NUMBER
DEP16304

Addendum Number: 02

Addendum – Questions asked during and after Pre-Bid Conference
Clarifications/Corrections to Bid Schedule, Scope of Work, Specifications and Drawings
DEP16304
HALLELUJAH MINING 40-81

HALLELUJAH MINING
PERMIT 40-81
DEP16304
PRESTON COUNTY, WEST VIRGINIA

25.1 - R LIMESTONE BED 1

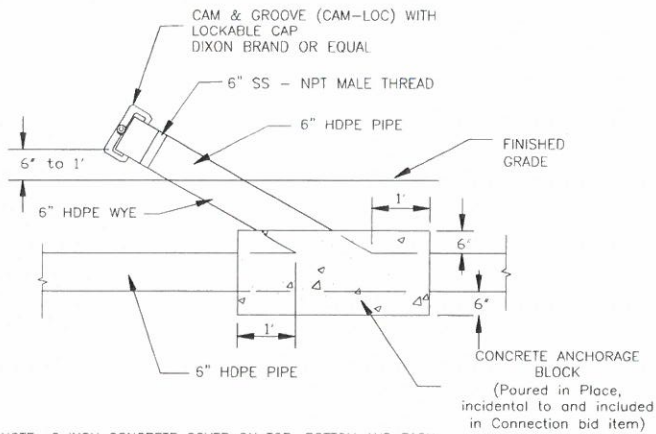
FOR THIS PERMIT: Install approximately eight hundred (800) tons of AASHTO #1 limestone to create Limestone Bed 1 north of the Manhole 2 for approximately one hundred sixty-five (165) feet long by twenty (20) feet wide by four (4) feet deep and discharge into Channel 5 as shown on the attached Overview Map and in details and specifications.

AQUA-FIX BUILDING MODIFICATION DETAILS

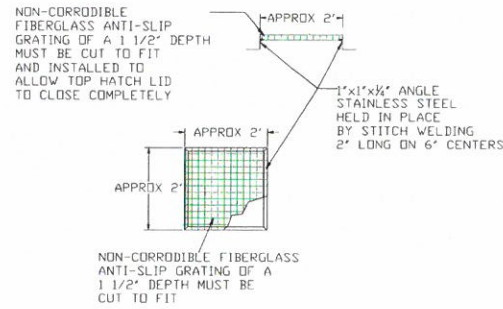
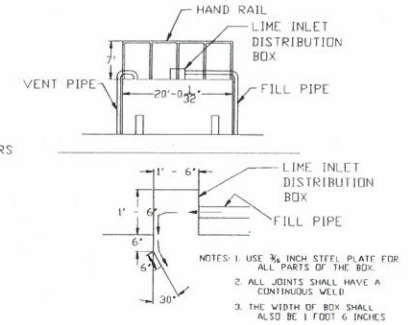
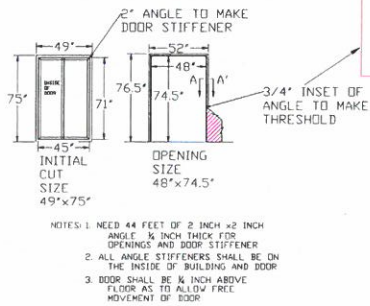
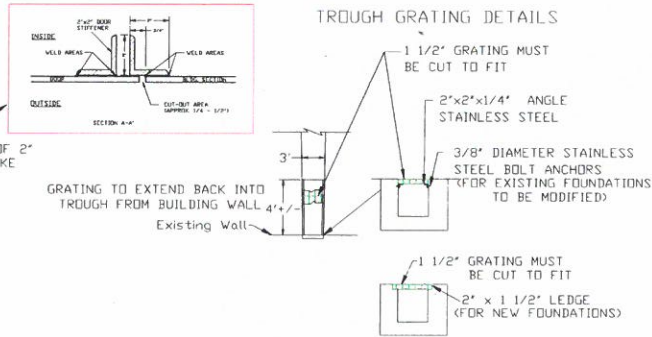
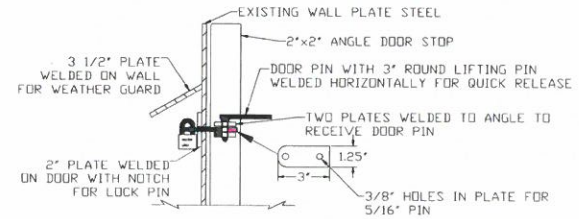
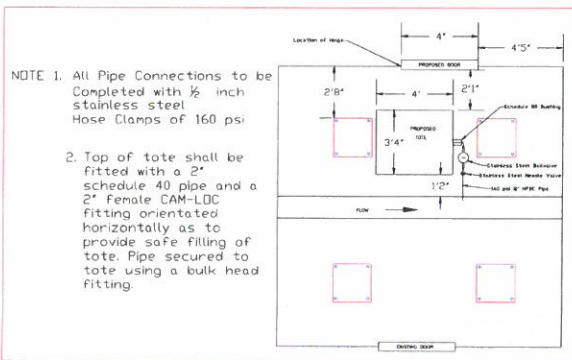
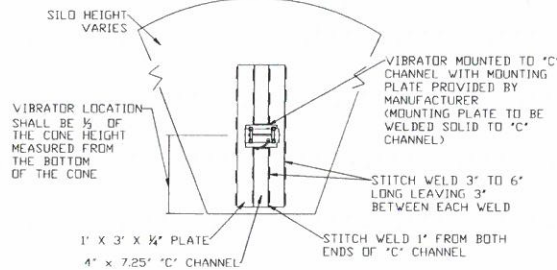
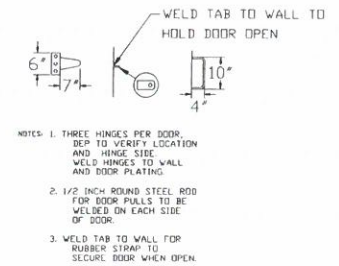
18.0 - R MODIFY EXISTING LIME DISPENSING UNIT STRUCTURE

Modification of the existing lime dispensing unit structure shall include the following upgrades. Payment shall be per each unit modified and approved by WVDEP. See attached drawings and details.

1. Four foot door shall be installed in accordance with the attached drawings and specifications. Steel for materials shall be of same grade as those existing on structure. The entirety of all adjoining surfaces of stiffeners shall be welded to insure structural integrity. Welding of stiffeners to the door and building steel sheets shall be by means of stitch welding (3" welds on 12" centers minimum). Line item shall also include all parts/materials shown in the Latch Detail View including door pin, two plates, two inch plate welded on door, 3.5-inch plate as a lock weather guard. The latch shall be made to either unlock door from outside, or open the door from the inside by removing the pin. Door shall also include three welded hinges, a door pull on each side of door, and a welded tab for holding door open on outside wall, see detailed drawings. Door installation shall include removing any affected insulation prior to door modifications, then replacement of insulation with original attachments

6. Lime Inlet Distribution Box will be mounted on the silo roof. Lime Inlet Distribution Box will be securely mounted to silo with a continuous weld to insure a dust and water tight enclosure. Target box will be designed to reduce the velocity of the chemical being conveyed and allow it to drop into the storage bin in an even pattern. The existing fill pipe will be modified to connect to target box and entire circumference of filler pipe will be welded to target box as to insure a dust and water tight connection.

10. Remove wench, wire rope, anchor and associated equipment from the lime dispensing unit structure and silo. Patch hole where the wire rope enters the silo with a metal patch, weld entire circumference of patch to silo.
